Pandora vertexing paper plot updates

FD Sim/Reco Meeting

- Currently in ARC review
- Responded to all comments
- Awaiting confirmation the reviewers are satisfied with those responses
- Presenting new plots and somewhat more heavily modified plots since the WG review for group sign off here
 - I am not including trivial modifications like line thickness, font size, etc

Fig 2: Distribution of true neutrino energy for the simulated samples up to 10 GeV

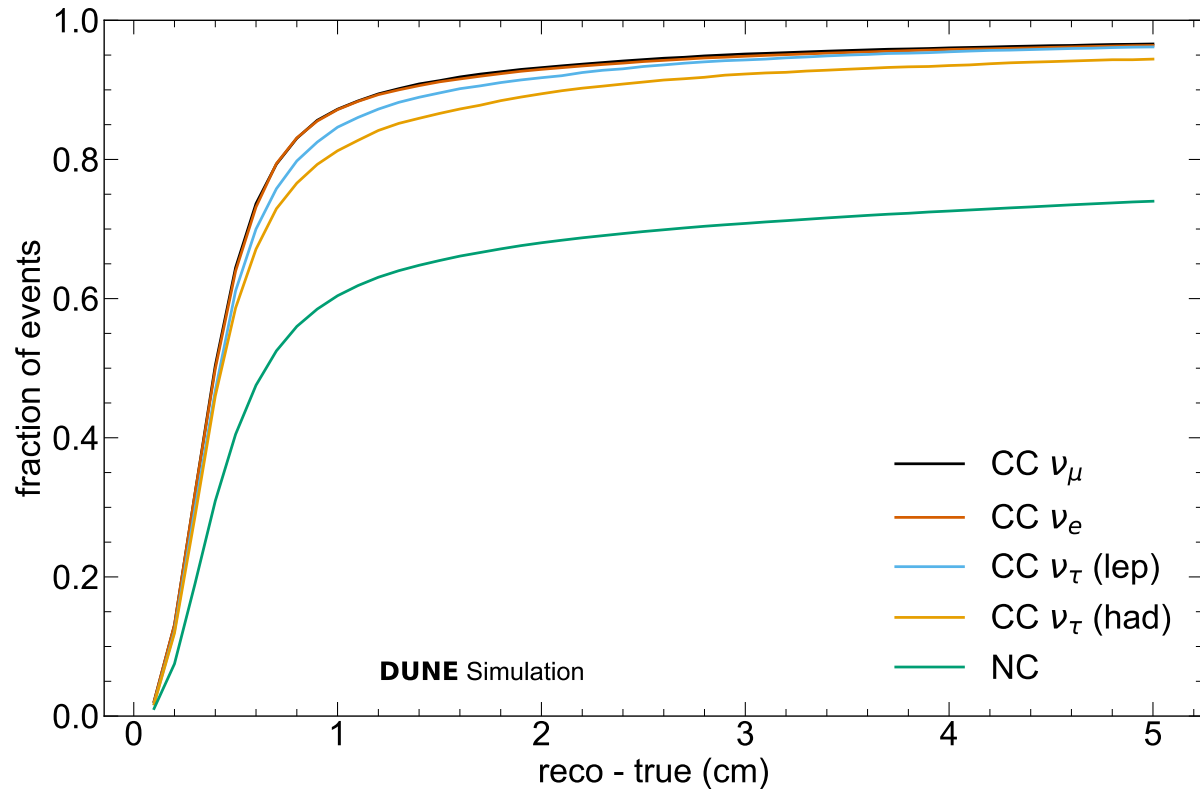
- Request for additional plot showing the true neutrino energy spectra for the samples

(will add overflow bin)

Fig 8: Fraction of vertices reconstructed within a given distance of the true neutrino interaction vertex ... (d) shows the performance of the new DL network for different currents, flavors and in the case of CC ν_τ interactions, for the leptonic and hadronic decays of the τ .

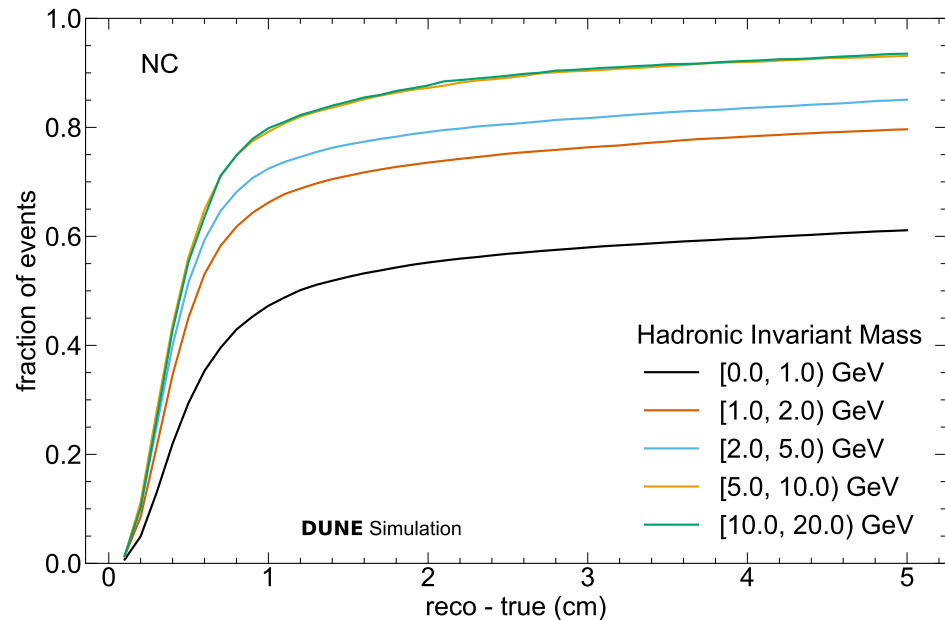
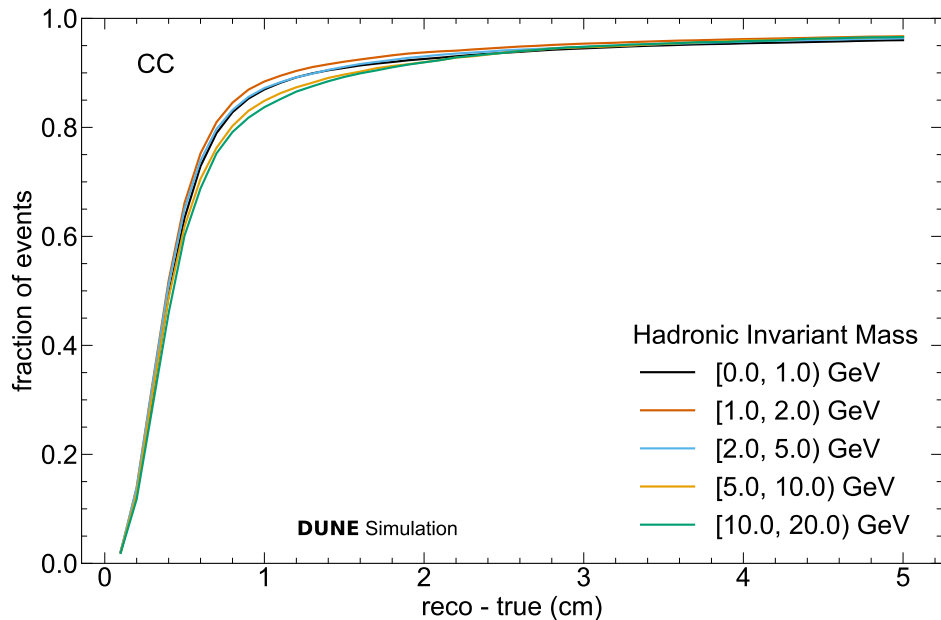
- Received request to combine performance per flavour (+NC) into a single plot along with a further breakdown of performance based on the nature of tau decays

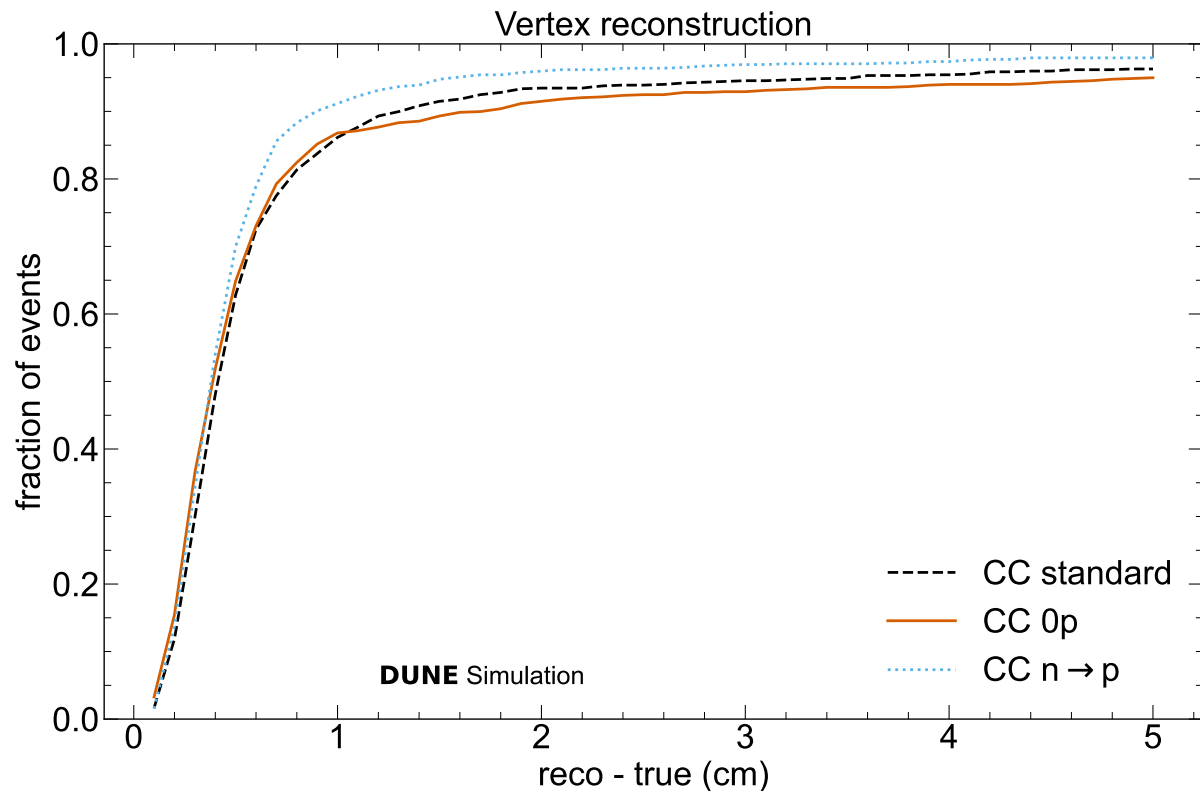
- Received request to add hadronic invariant mass alongside inelasticity plots

Fig 14: Fraction of reconstructed vertices as a function of distance to the true vertex for the standard, n→p and 0p samples, split into (left) CC and (right) NC interactions.

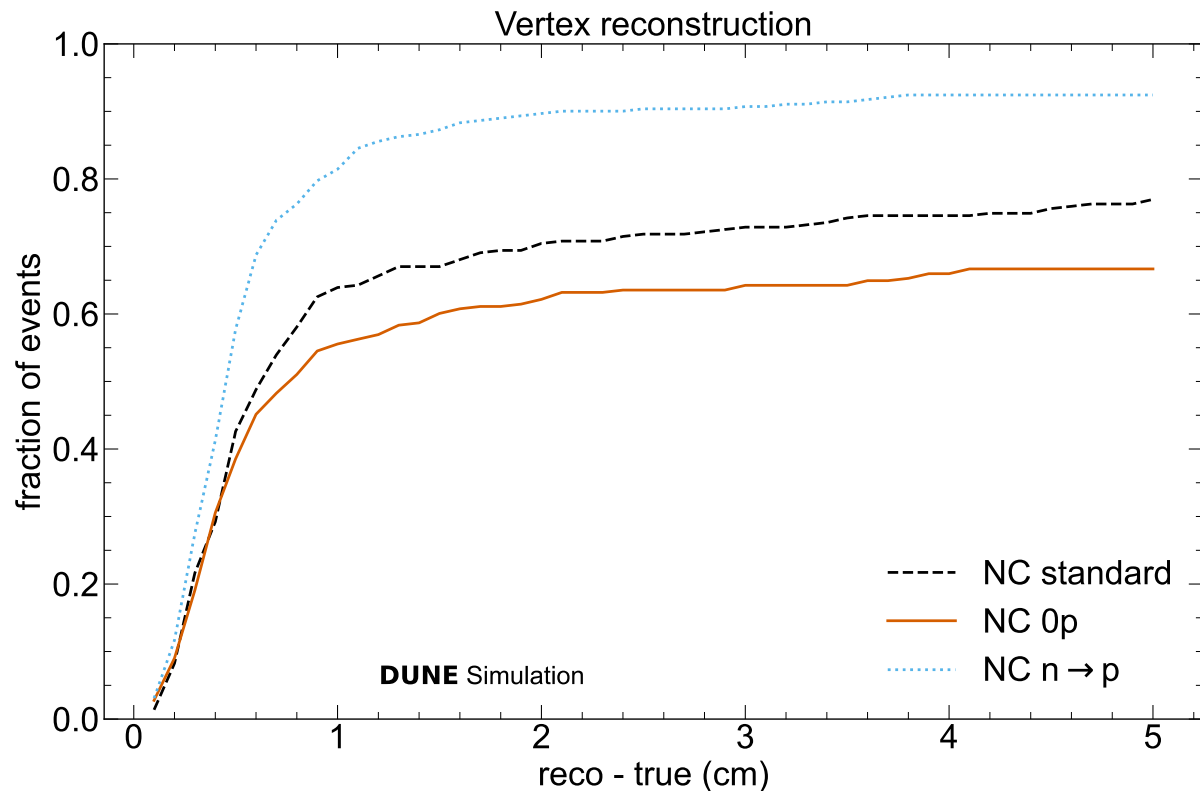
- Previously had pair-wise comparisons of the different “models”, request to combine them into one plot

Fig 14: Fraction of reconstructed vertices as a function of distance to the true vertex for the standard, n→p and 0p samples, split into (left) CC and (right) NC interactions.

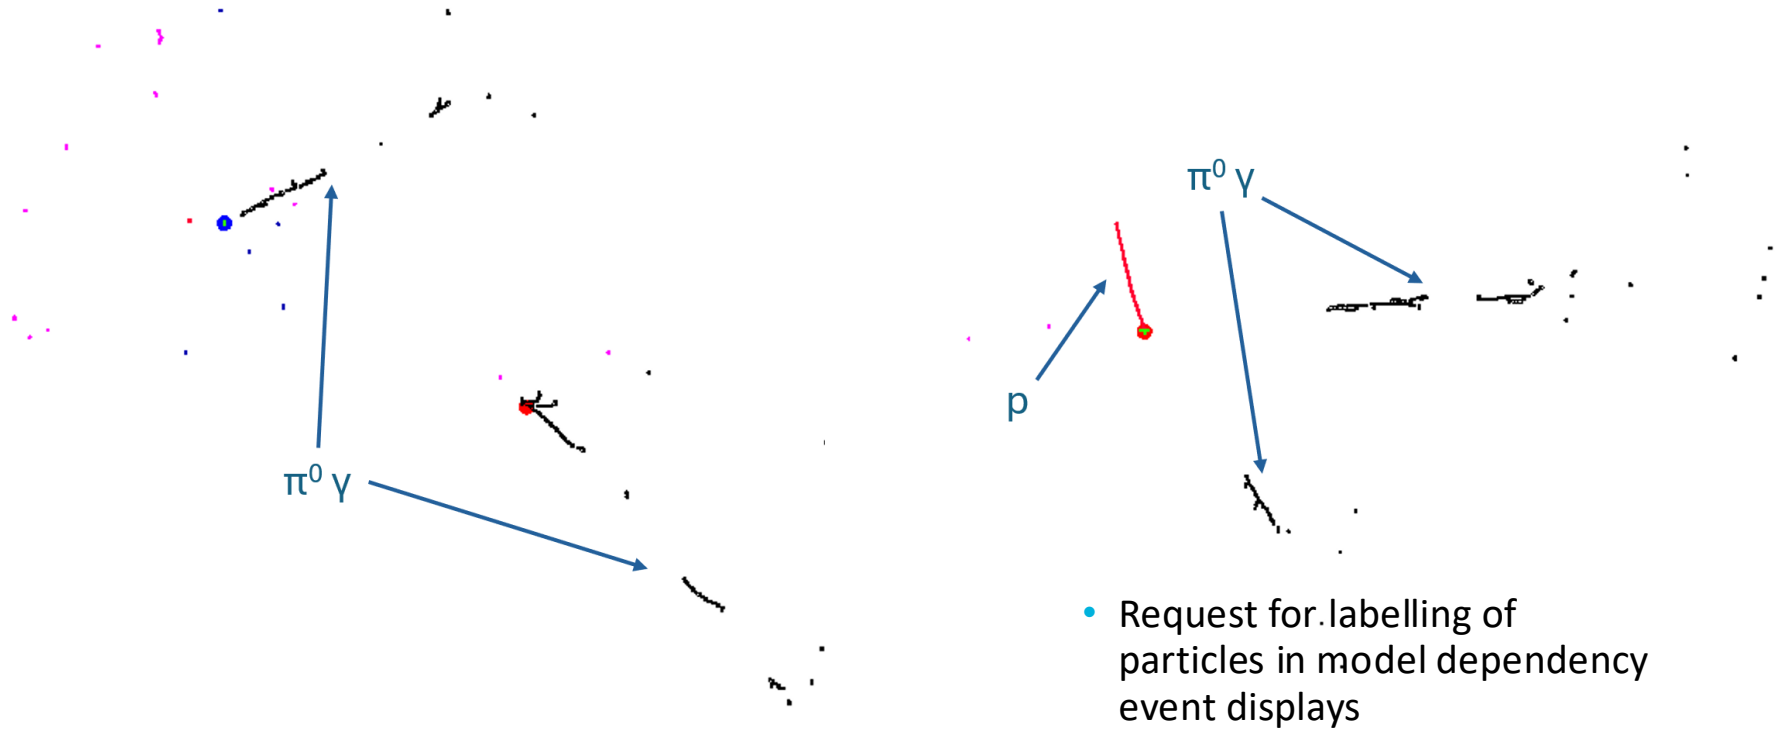
- Previously had pair-wise comparisons of the different “models”, request to combine them into one plot
